# MEMORANDUM

SUBJECT: Site Plan Approval – 1067 Marble Street, VL-1 Marble Street and VL-8 Water Street

DATE: December 28, 2023

Re: Site Plan Approval – Hale Transportation Building Addition

Calculation Summary							
Label	CalcType	Units	Avg	Max	Min	Avg/Min	Max/Min
Object_3_Planar	Illuminance	Fc	0.82	4.0	0.0	N.A.	N.A.

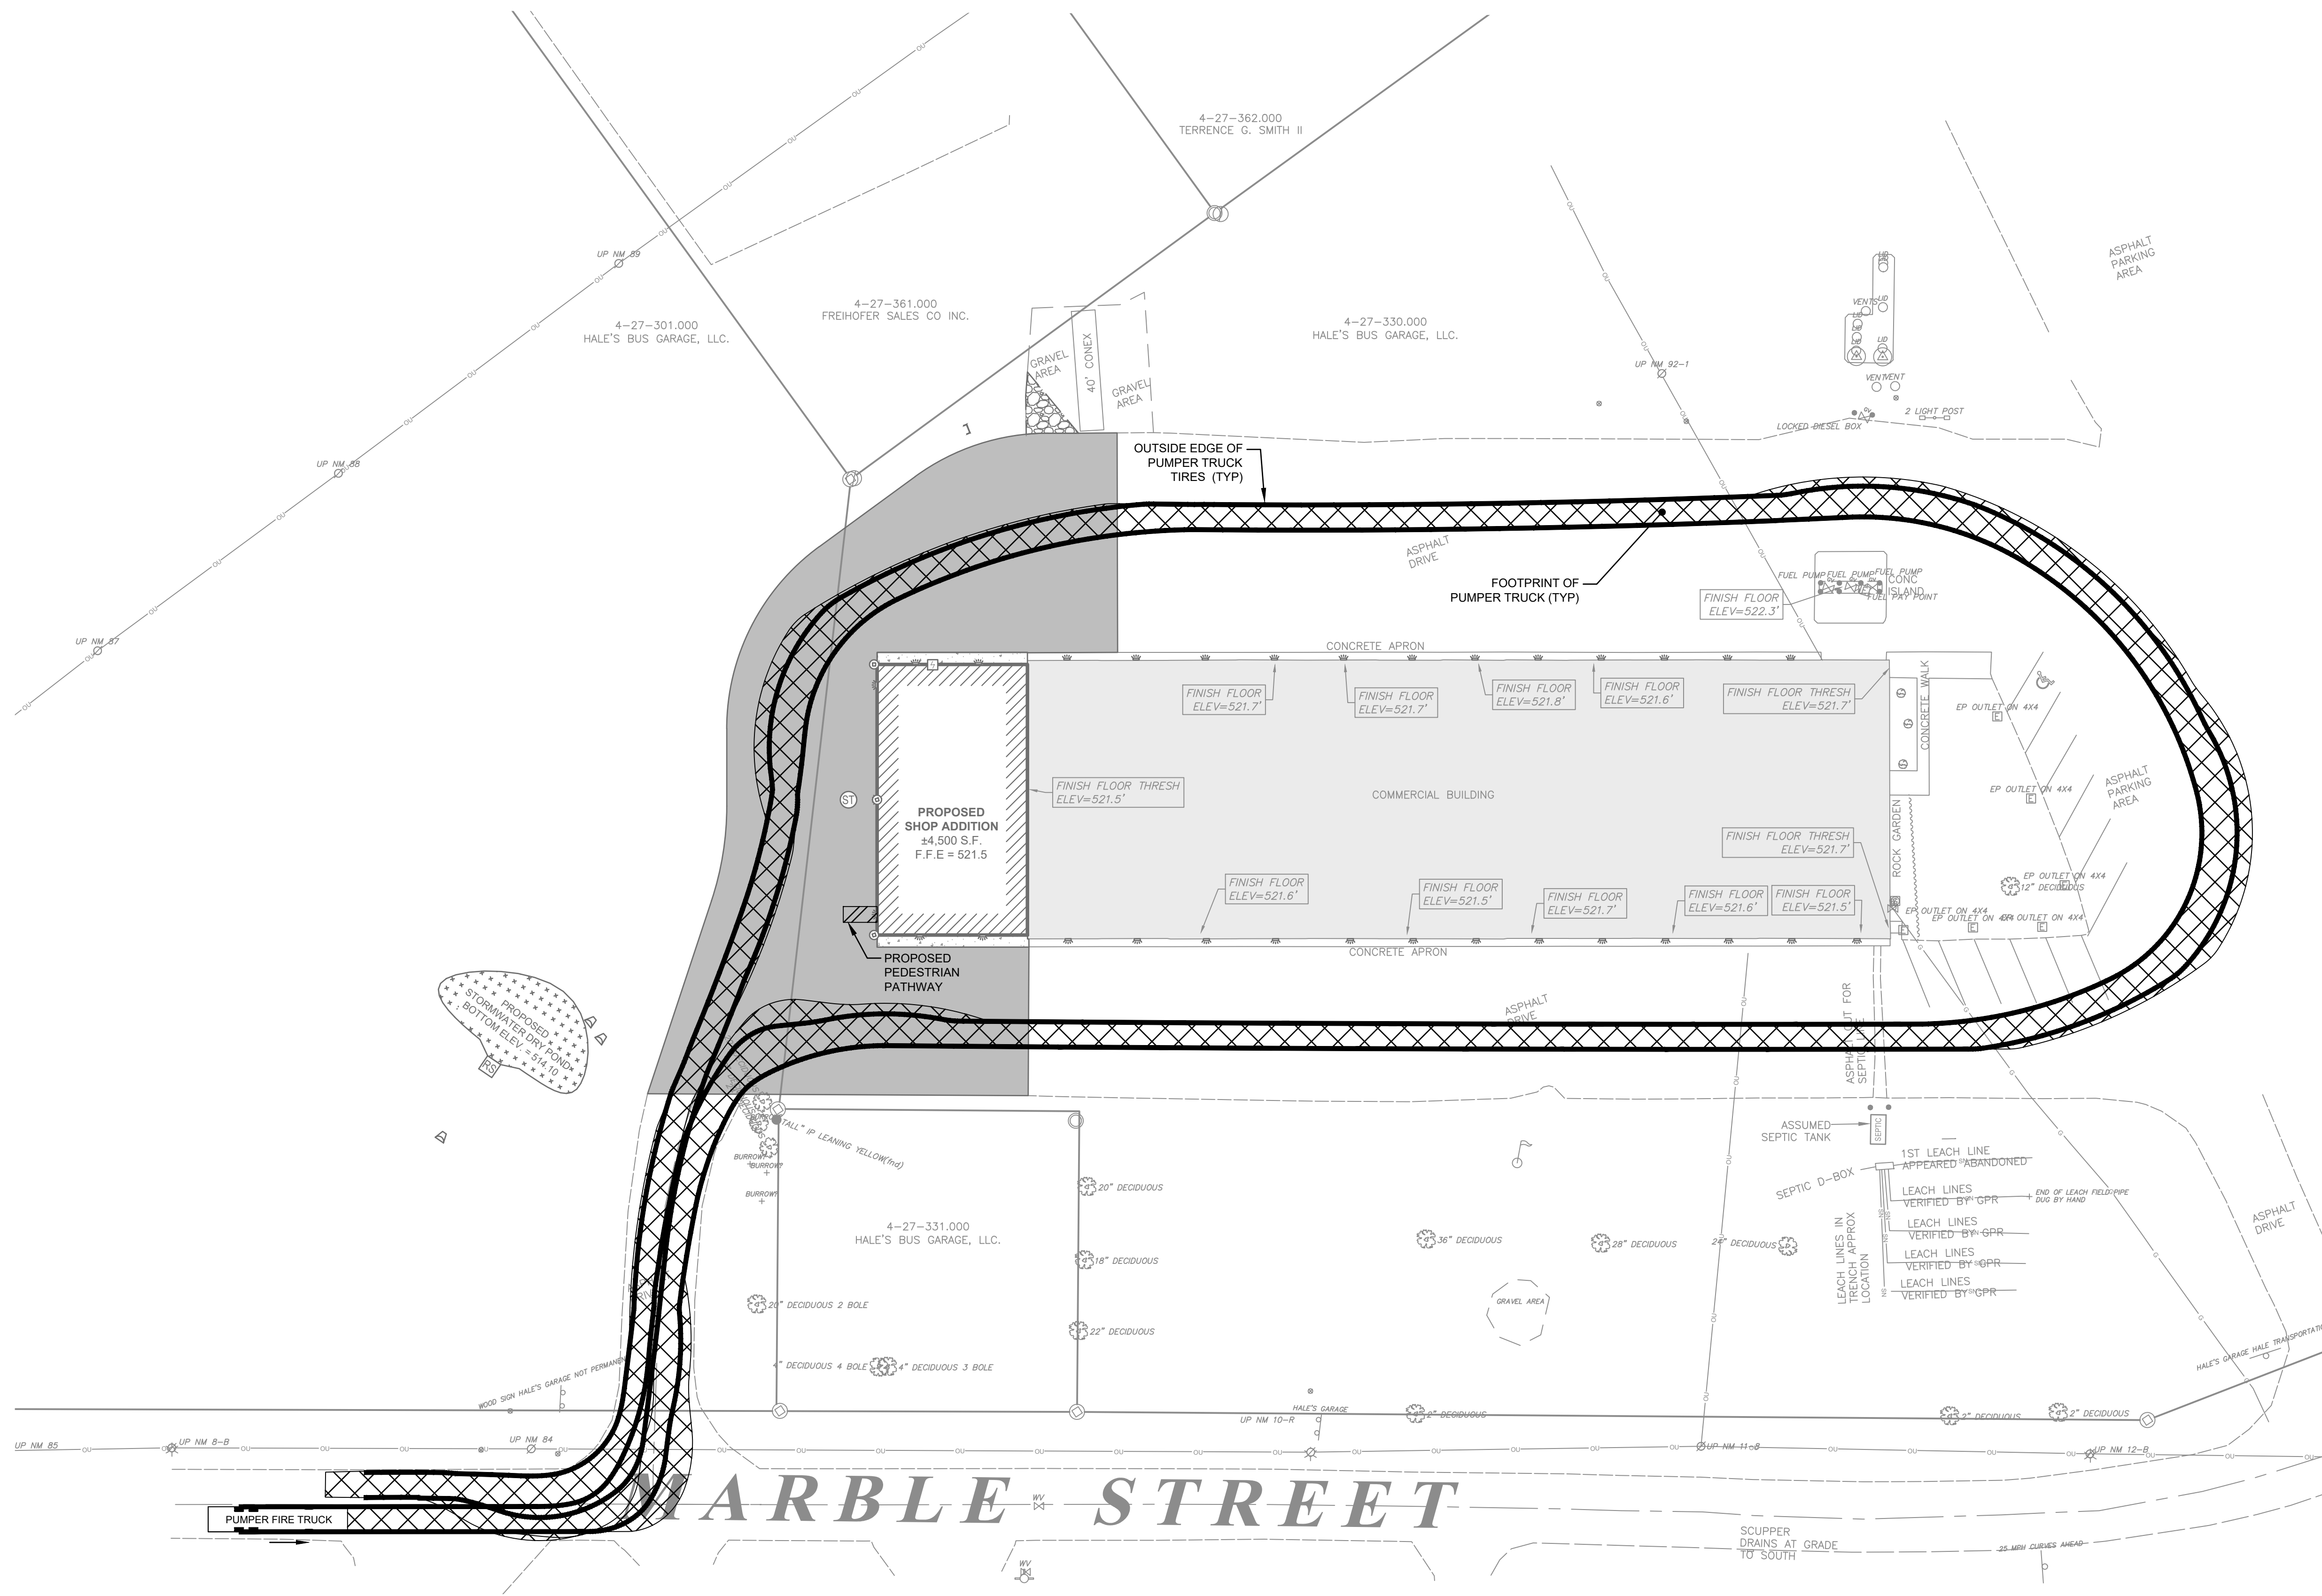
9. The applicant shall be prepared to discuss light spillage across property lines as it relates to the property owner's intentions for the three subject parcels. The Zoning Ordinance prohibits spillage of more than 0.5 footcandles across any property line. *The applicant has acknowledged this recommendation and communicated an intent to assemble all three parcels into a single parcel. Assembling the parcels would alleviate all concerns regarding light spillage over property lines. Staff suggests that the condition be modified as follows and remain as a summary item: **If the subject parcels are not combined by way of a new metes and bounds description, the applicant shall modify the lighting plan so that there is no more than 0.5 footcandles of light spillage across the property line.***

**Lighting:** The applicant submitted a Photometric Plan. Section 310-84 (C)(2) of the Zoning Ordinance requires that light trespass shall not exceed 0.5 footcandles at the property line. The Photometric Plan depicts up to 2.0 footcandles of spillage across the western property line onto VL-8 Water Street. This will not be an issue if the applicant chooses to assemble the properties after closing on VL-8. However, this will become an issue if they remain separate. The applicant shall be prepared to discuss the property owner's intentions for parcel assemblage and the implications of light spillage if the lines remain where they are. The Planning Commission is not able to approve a Site Plan that will result in permanent illegal light spillage.

9. The applicant shall be prepared to discuss light spillage across property lines as it relates to the property owner's intentions for the three subject parcels. The Zoning Ordinance prohibits spillage of more than 0.5 footcandles across any property line.
  - a. **See the response to Summary Item 2 above.**

**5 TYPICAL TREE PROTECTION DETAIL**  
C503 NOT TO SCALE

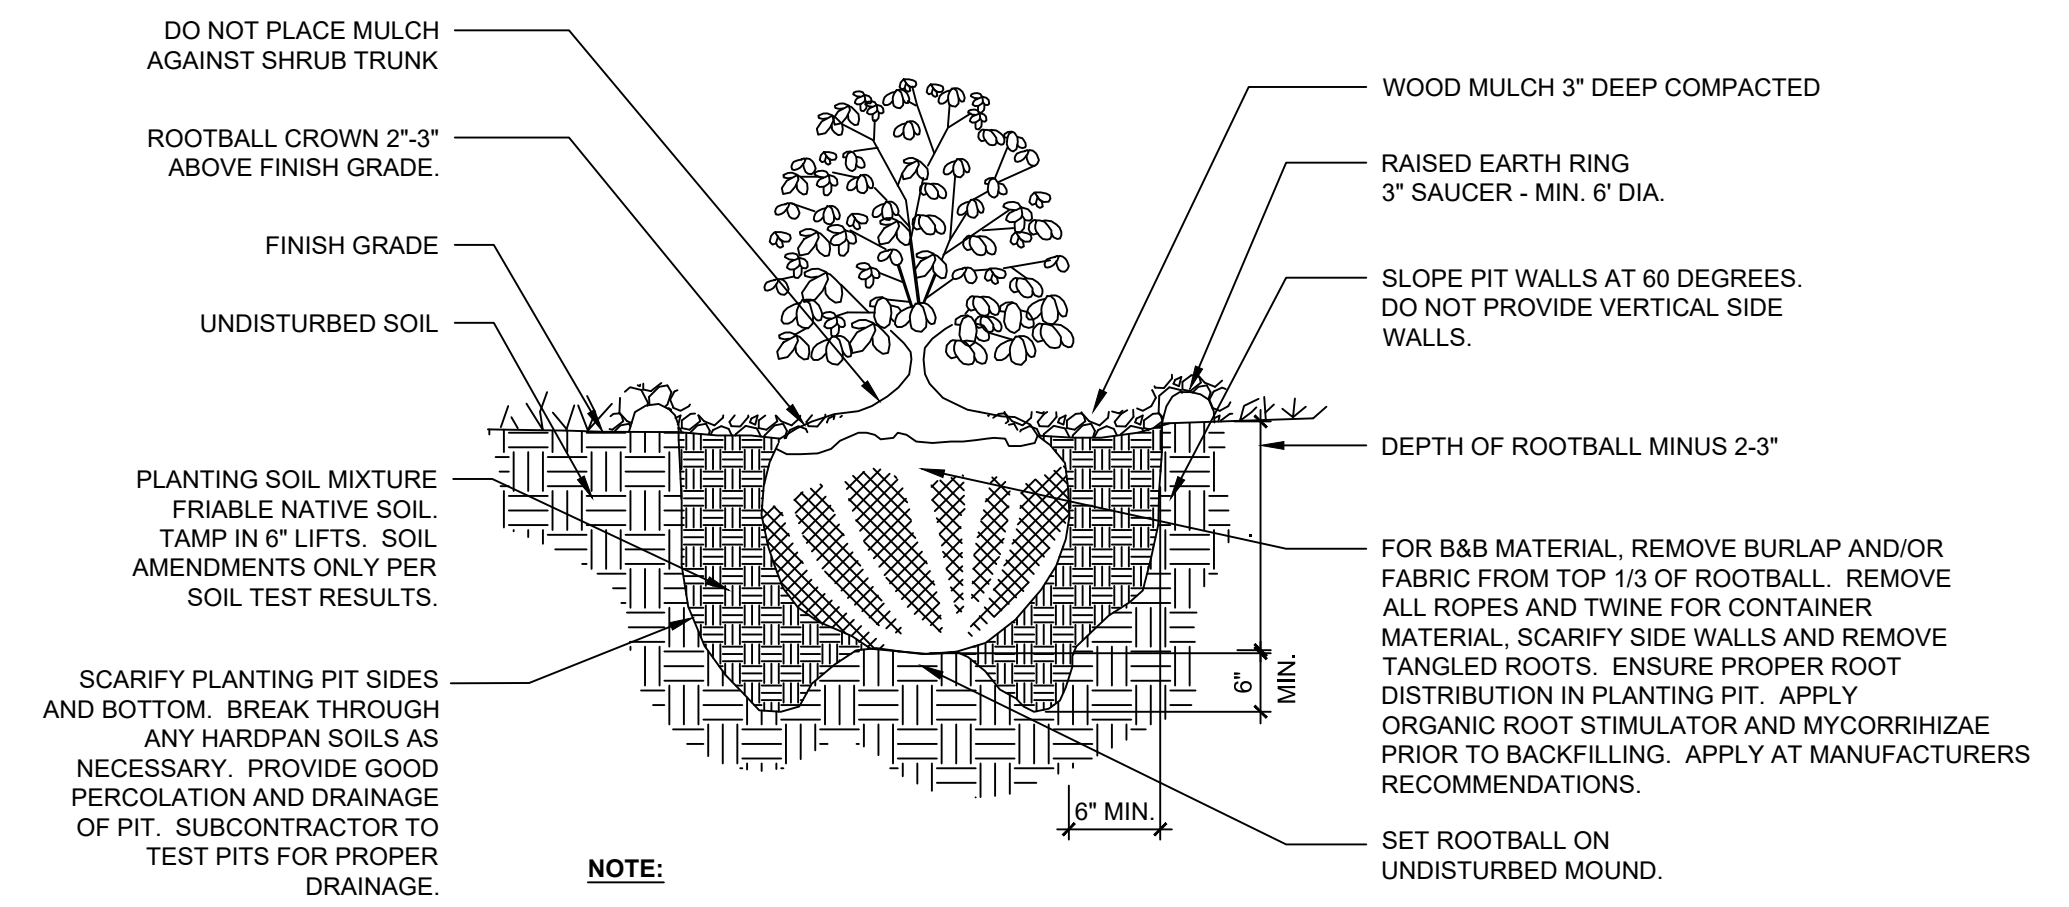
8. The applicant should establish tree protection around the existing deciduous trees adjacent to the western entrance drive and avoid parking construction vehicles or storing equipment or materials within their canopies. *This item is satisfied. The applicant has added tree protection to the Demolition Plan and a tree protection detail to the Site Detail sheet. The applicant should note that tree protection zones are most effective when communicated as a priority throughout all ranks of the construction team and installed prior to staging or storing of any project related equipment or materials.*

8. The applicant should establish tree protection around the existing deciduous trees adjacent to the western entrance drive and avoid parking construction vehicles or storing equipment or materials within their canopies.
  - a. **Tree protection has been added to the Demolition Plan, and a tree protection detail has been added to C503.**
